Model	ADF for E7	Volt/Hz	Date of Modification	Serial Number
Modified Article	Parts Catalog			
Reason for Modification	Parts catalog correction

MODIFICATION BULLETIN NO. 12

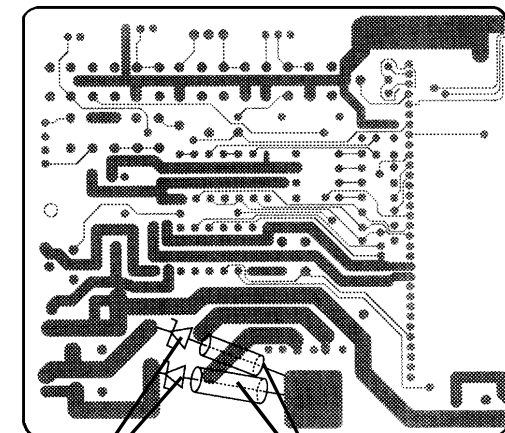
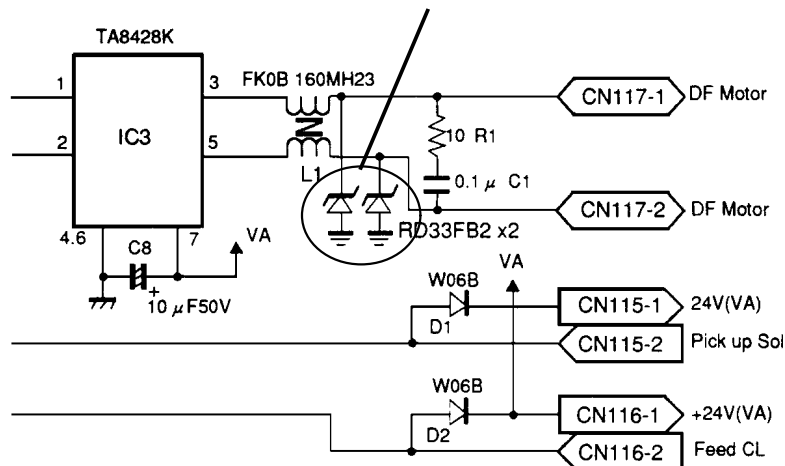
According to this correction, the schematic of the main board has been changed as follows.

These two zener diodes have been added.

Two tubes have been added to protect the zener diodes.

P/N	Description	Q'ty	Page	Index
14021125	Zener Diode - 1W-RD33FB2	2	13	150*
11060701	Tube - 0.8	2	13	151*

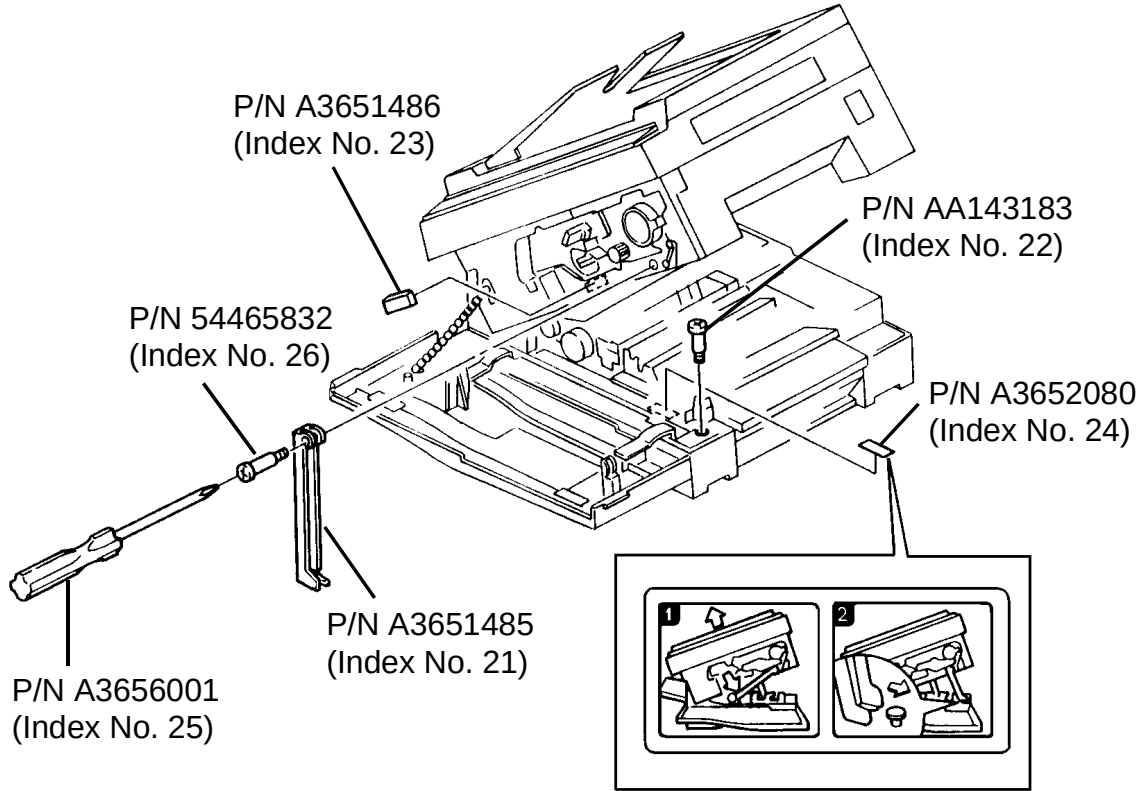
To hold the upper unit and ADF at a proper position, the following parts have been packed as an accessory to the ADF.

P/N	Description	Q'ty	Page	Index
A3651485	Upper Unit Stand	1	5	*21
AA143183	Stepped Screw	1	5	*22
A3651486	Magnet	1	5	*23
A3652080	Instruction Decal	1	5	*24
A3656001	Screw Driver	1	5	*25
54465832	Connector Guide Pin	1	5	*26

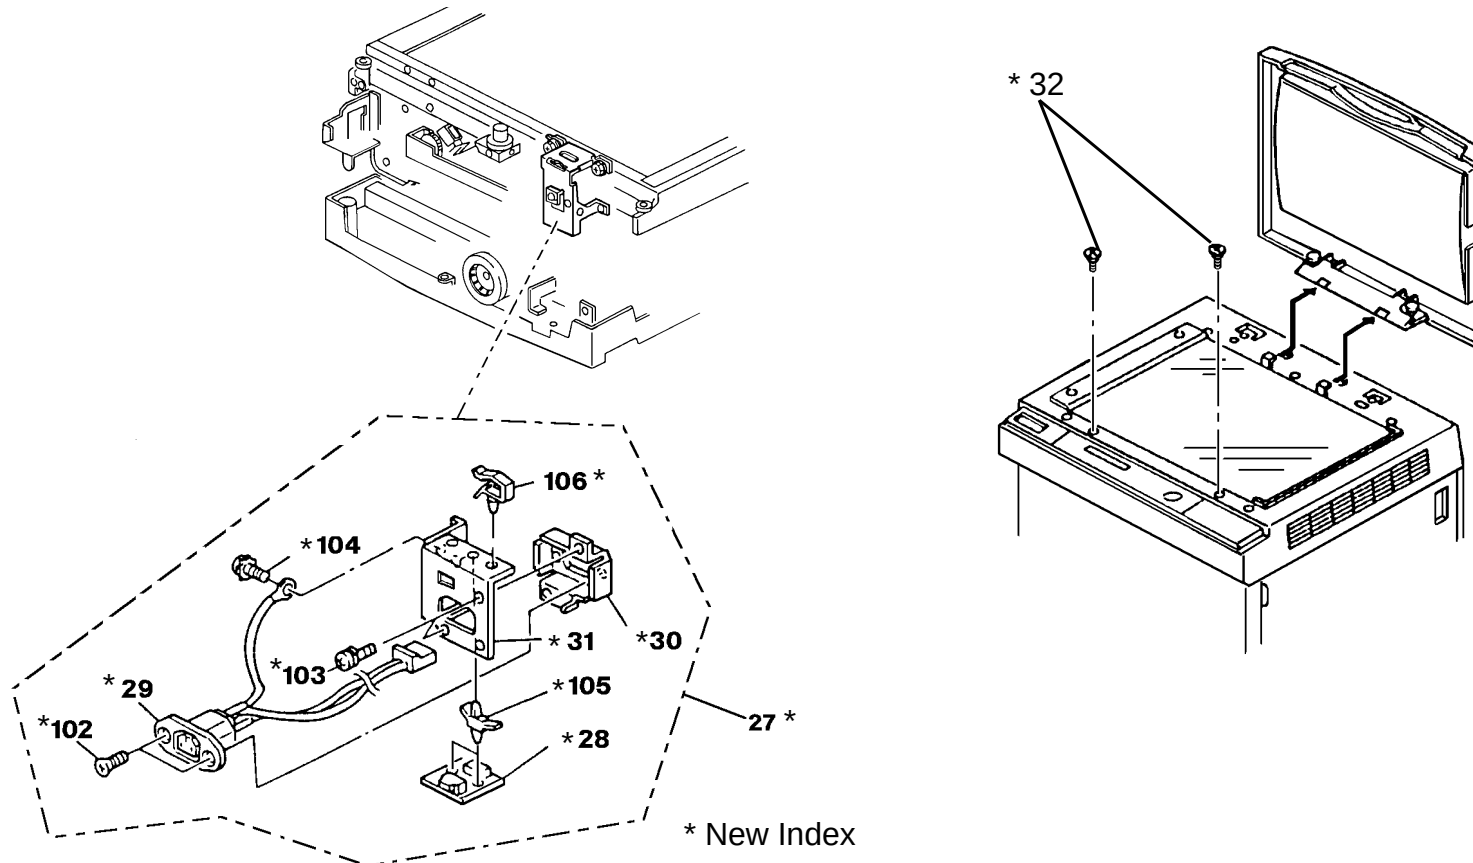
To make it possible to equip the Robin with this ADF, the following parts have been added as a DF accessory.

NOTE: When the DF without these accessory parts is installed on the Robin, the following parts are needed.

115V version : P/N A3650661 --- 1pc
P/N A0771361 --- 2pcs

220 ~ 240V version : P/N A3650662 --- 1pc
P/N A0771361 --- 2pcs

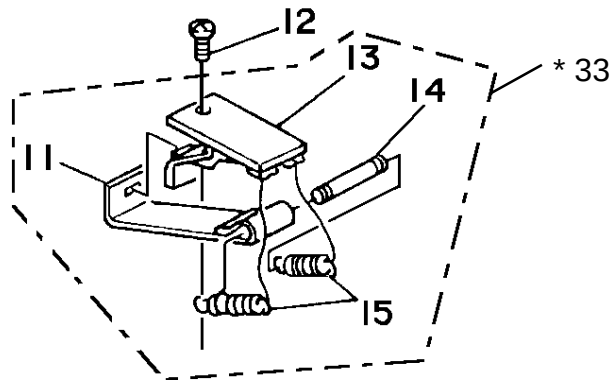
At the field's request, the friction belt assembly has been registered as a service part.

Old P/N	New P/N	Description	Q'ty Used	Inter-change-ability	Parts Catalog	
					Index No.	Page
	A3650331	Friction Belt Ass'y (Ricoh)	0 → 1		* 33	5
	A3650333	Friction Belt Ass'y (SAVIN)	0 → 1		* 33	5
	A3650335	Friction Belt Ass'y (Infotec)	0 → 1		* 33	5
	A3650337	Friction Belt Ass'y (NRG)	0 → 1		* 33	5

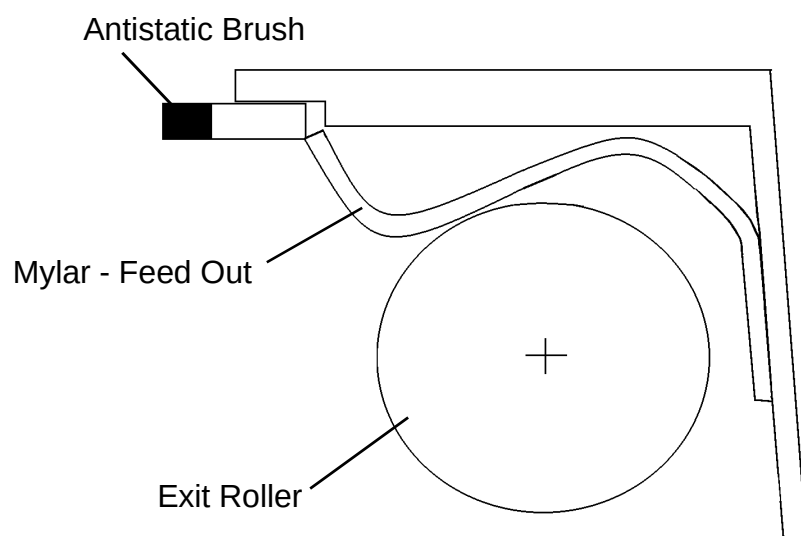
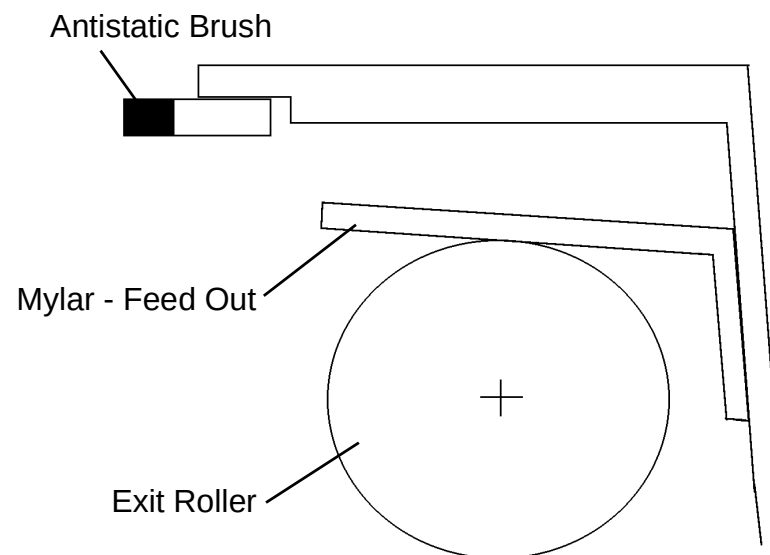
To facilitate manufacturing, the feed-out mylar has been changed.

With the old mylar, the end of the mylar was inserted into the gap between the cover and the antistatic brush. With the new mylar, the edge is free and a thicker material is used.

Old P/N	New P/N	Description	Q'ty Used	Inter-change-ability	Parts Catalog	
					Index No.	Page
H5201450	A3951450	Mylar - Feed Out	1 → 1	X/O	25	11

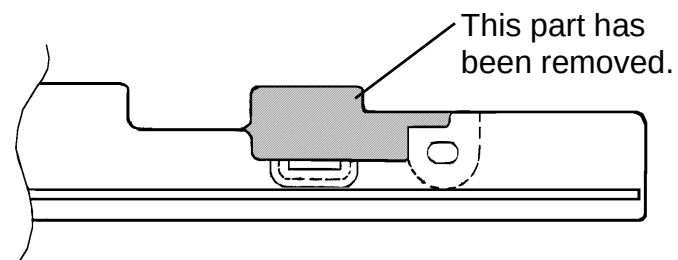
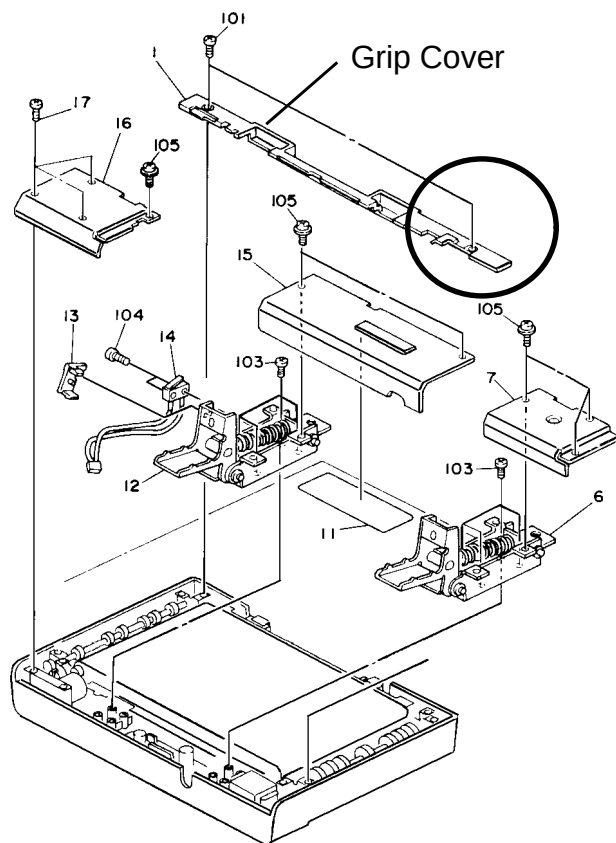
To prevent interference with the exit roller drive belt, a part of the grip cover has been removed.

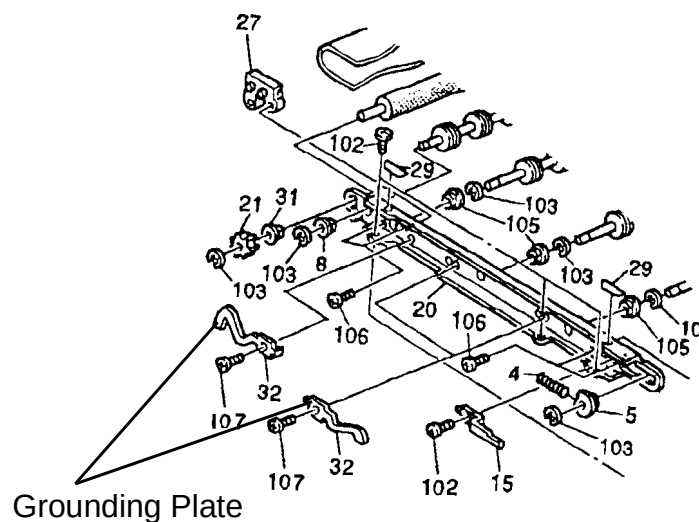
Please add the following parts to your parts catalog.

P/N	Description	Q'ty Used	Parts Catalog	
			Index No.	Page
A3951108	Grounding Plate	3	29	11
03440060W	Philips Truss Head Screw M4 x 6	3	107	11
